PROJECT
ETHYLENE GLYCOL PROJECT
PARADIP REFINERY, ODISHA-INDIA.

TITLE
UNIT NO–207D
CIVIL DRAWING FOR DOCK LEVELER

SCALE 1:1
DWG. NO. IPEG–6389–NTPL(1)–8470–43–207D–0001
REV. A2
1/1

PLAN VIEW

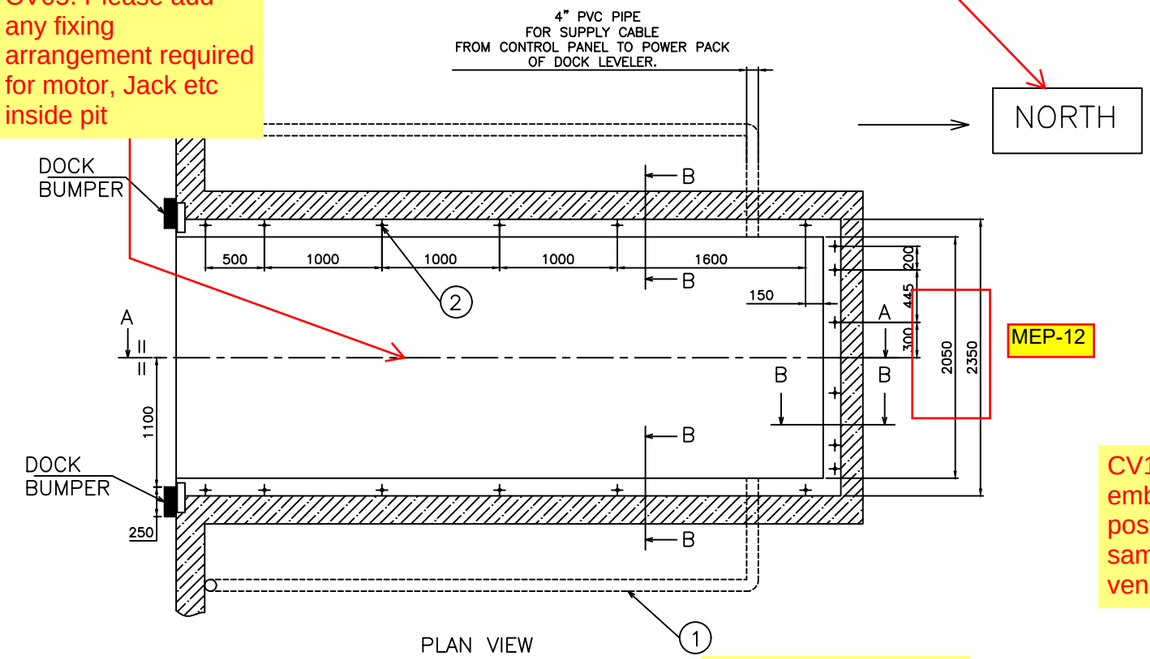
CV04. Please check north

CV05. Please add any fixing arrangement required for motor, Jack etc inside pit

CV2. Please clear OK-FF, OK-RF

CV1. Fixing of any embedded shall be post installed and same shall be by vendor.

ELEVATION VIEW

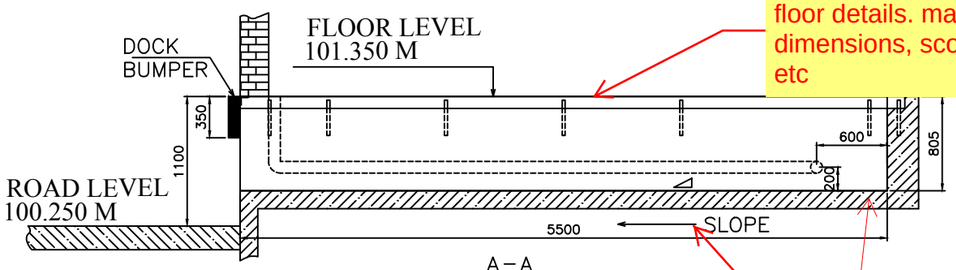
CV03. Please provide floor details. material, dimensions, scope etc

SIDE VIEW

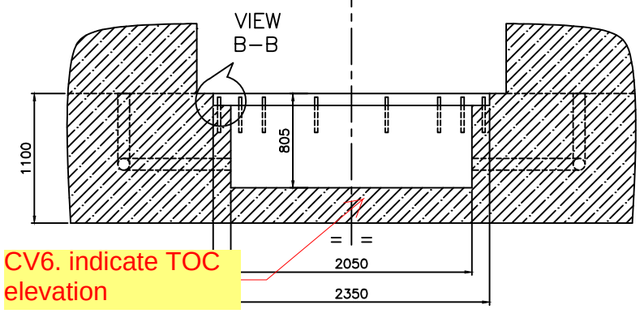
CV6. indicate TOC elevation

CV6. indicate TOC elevation
